To: HDB Town Planning and Design
Email: Aprajita Gupta, Aprajita@hdb.com.au
Date: 14 June 2022
Subject: Dalswinton Quarry Groundwater Impact Assessment – Response to DPE Advice
Project number: 4047

2. DPE advice

Figure 3.1 Representation of the Hunter River – shown in red

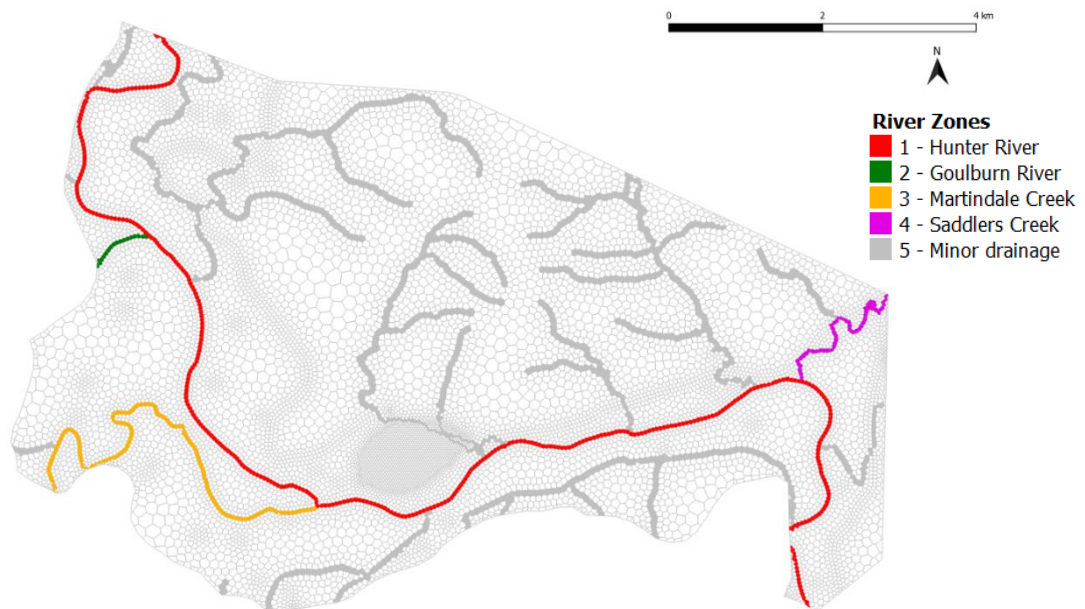
2.1.a - Review the conceptualisation and how the conceptualisation is transferred to the numerical model to ensure aquifer interference activities and their impacts are represented in the groundwater model and have the ability to predict potential impacts on the river and aquifer (and other groundwater values) during and post closure of the quarry operation (see Section 3.2).

2.1.c - Review groundwater inputs to include groundwater take that includes evaporative groundwater loss from the voids; incidental take with quarried aggregates; and dewatering and take for processing demands (see Section 3.2.1 and 3.2.2). This would also include the need to clarify whether post closure void (landform) intercepts aquifers, and if so, estimate the ongoing groundwater take post closure (see Section 3.2.3).

The Hunter River is a perennial watercourse which is supplemented by upstream water storages. There are three gauging stations located near the project which provide a long term, transient record of surface water elevations and flows. Whilst no site-specific groundwater level data is available, the availability of long term, transient records of surface water elevations and flows allows for the extrapolation of this data along the alignment of the Hunter River. The representation of the Hunter River and other tributaries within the numerical model is shown below in Figure 3.1 and is further summarised in the original groundwater impact assessment.

The Hunter River is numerically represented in the model using the RIV package. Steady-state river stage elevations for the Hunter River were based on the long-term averages from gauging stations at Denman (GS 210055) and Liddell (GS 210083). These were then extrapolated along the length of the Hunter River alignment. For the transient simulation, river stage elevations were varied based on the historical monthly average levels from the gauging stations and were extrapolated along the length of the Hunter River alignment. During average periods of high surface water elevations in the Hunter River, the RIV package allows additional water to enter the model domain to flow into the alluvial sediments. Therefore, the model is able to simulate the interaction between the Hunter River and the Hunter River alluvial water source and allows for seasonality.

Figure 3.3 Predicted water take

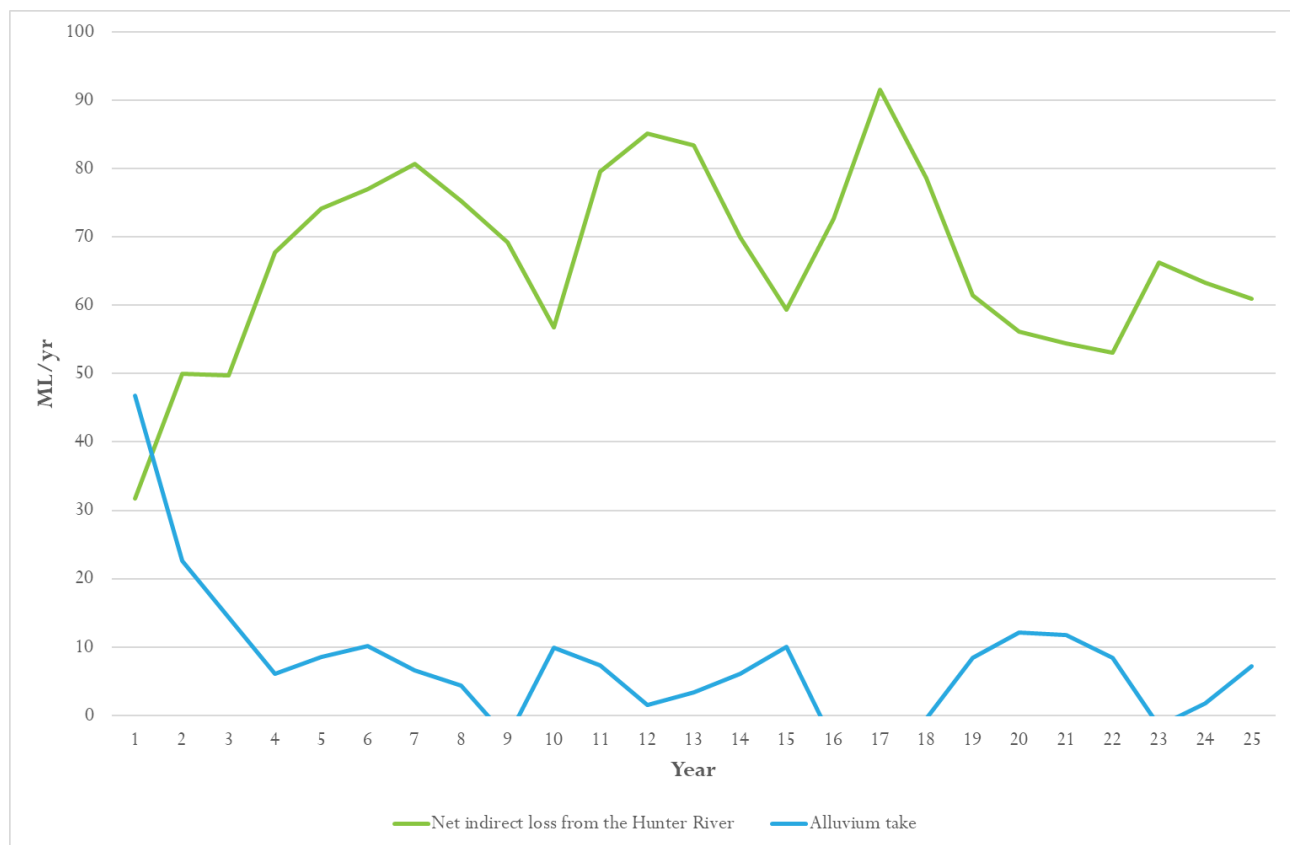
1.1 - The proponent should provide clarification of the maximum groundwater and surface water take, site water demands and the ability to obtain additional water entitlement where required for the project (see Section 3.3).

Figure 3.3 shows the predicted water take by the project from the Hunter River and Hunter River alluvial water source respectively. The bulk of the water predicted to be extracted by the project comes from the Hunter River (with a maximum of 91.52 ML/yr in Year 17), whereas the water taken from storage in the Hunter River alluvial water source comprises a small percentage of the overall water take. The exception to this is in the first three years of operation where the storage in the alluvium is initially depleted. This depletion causes localised drawdown in the alluvium which then induces flow from the Hunter River into the alluvium to compensate for the drawdown. In the first year of operation there is 46.79 ML/yr taken from the Hunter River alluvial water source. This rapidly decreases to generally less than 10 ML/yr in Year 4.
